SITE DEVELOPMENT PLANS FOR 1360 WALTON BOULEVARD PROPOSED STARBUCKS

Site Plan Review		
Reviewed for compliance to the City Ordinance, Building and Fire Codes		
Department	Reviewer	Approved
Planning	Kristen Kapelanski 248-841-2772 KapelanskiK@RochesterHills.org	No
Building	NA	
Engineering	Jason Boughton 248-841-2490 BoughtonJ@RochesterHills.org	Yes
Traffic	Keith Depp 248-841-2503 DeppK@RochesterHills.org	Yes
Nat. Resources	Matt Einheuser 248-841-2551 EinheuserM@RochesterHills.org	Yes
Fire	Lt. Ann Echols 248-841-2701 EcholsA@RochesterHills.org	Yes

Conditions and mark-ups noted throughout the plan set must be addressed prior to final approval.

COVER SHEET

C-1

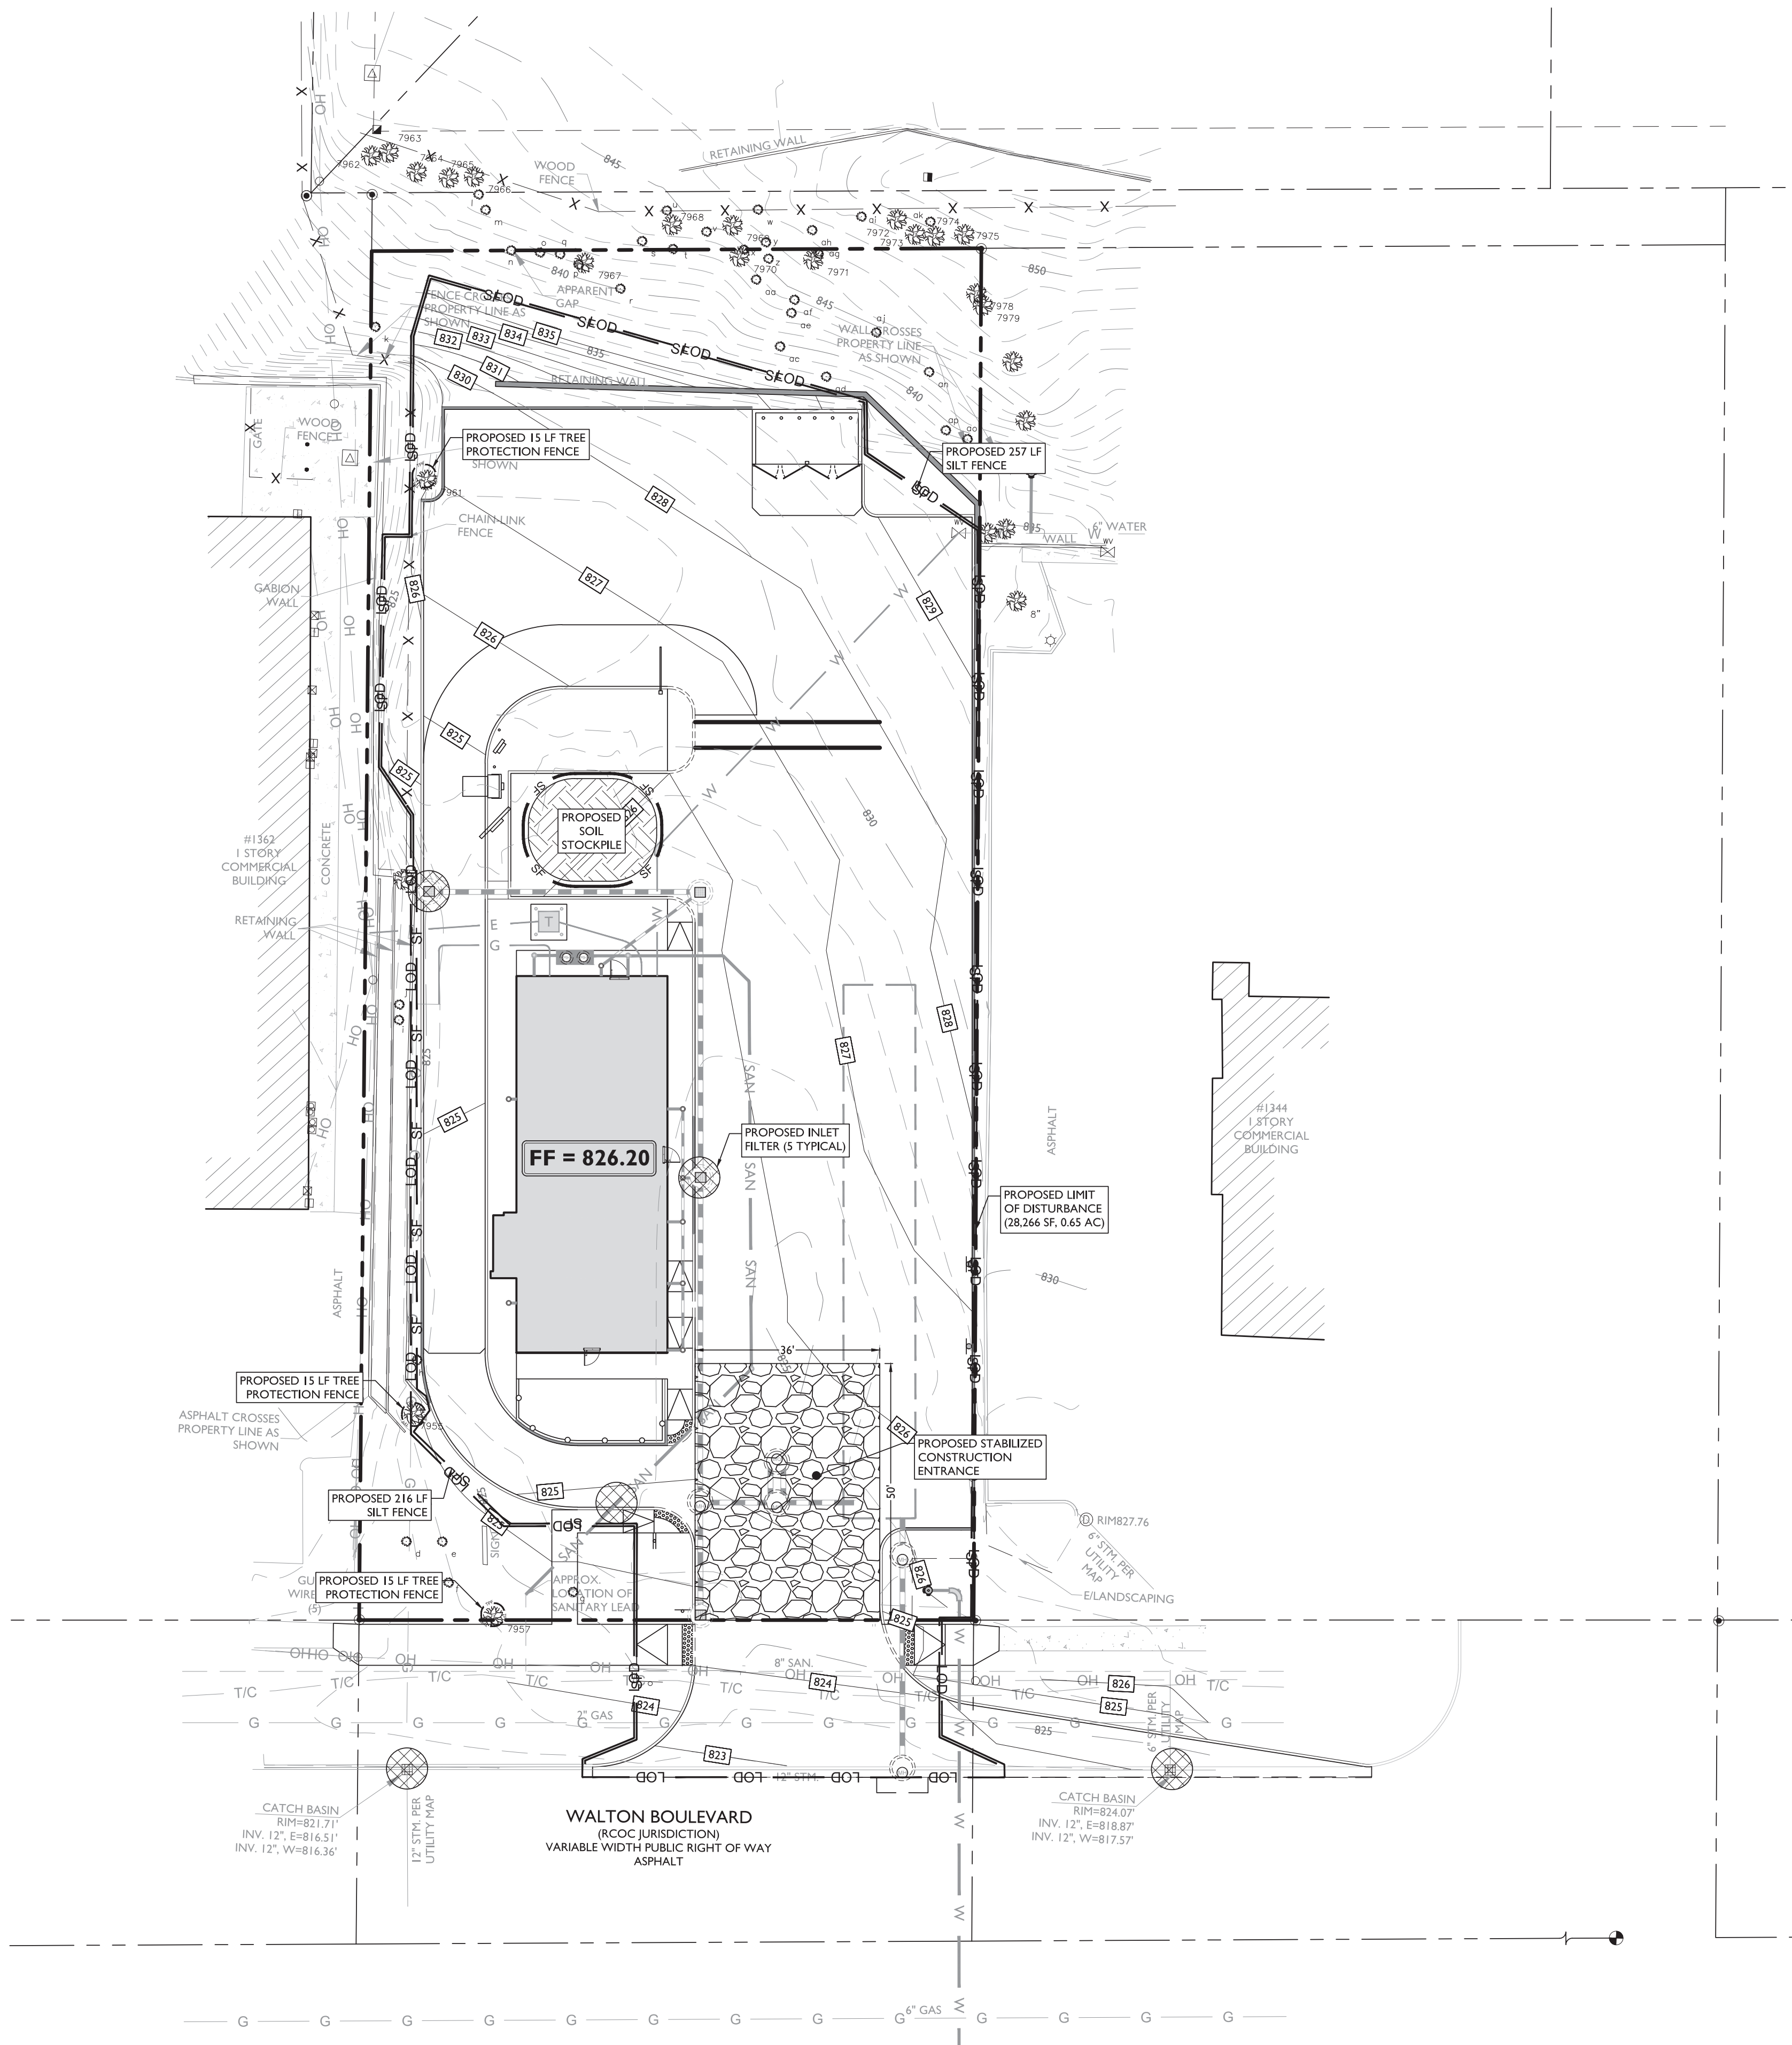
A conditional use permit is required for the proposed drive-through. Refer to Section 138-1.203 of the Zoning Ordinance for required signage that must be placed on the property 15 calendar days prior to the public hearing.

A traffic queuing study of other Metro-Detroit Starbucks should be provided showing average stacking spaces utilized during peak hour(s). Based on staff's experience with the Planning Commission, they will request this information as part of their analysis of the conditional use permit request. This must be provided prior to consideration by the Planning Commission.

The applicant needs to submit a Land Improvement Permit (LIP) application with engineer's estimate, fee and construction plans to proceed with the construction plan review process.

C-10

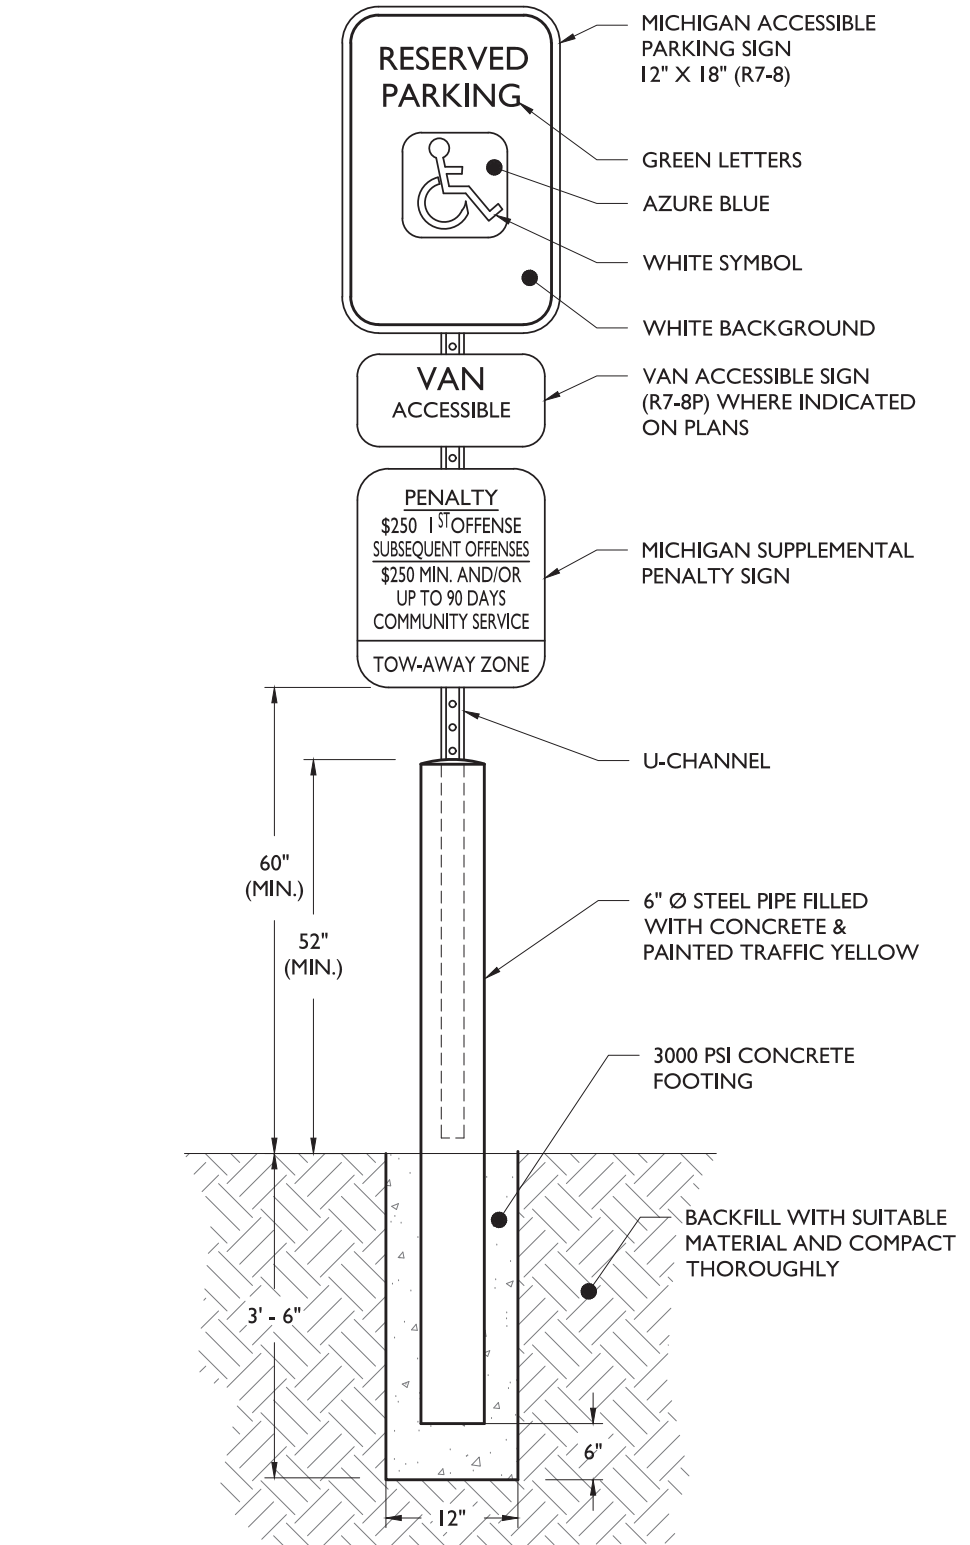
Include Road and Pathway Sight Lines. See attached details and include with the plan detail sheets.

The response letter indicates the submission of a landscape cost estimate but this could not be identified in the plans. A landscape planting cost estimate including irrigation should be provided.
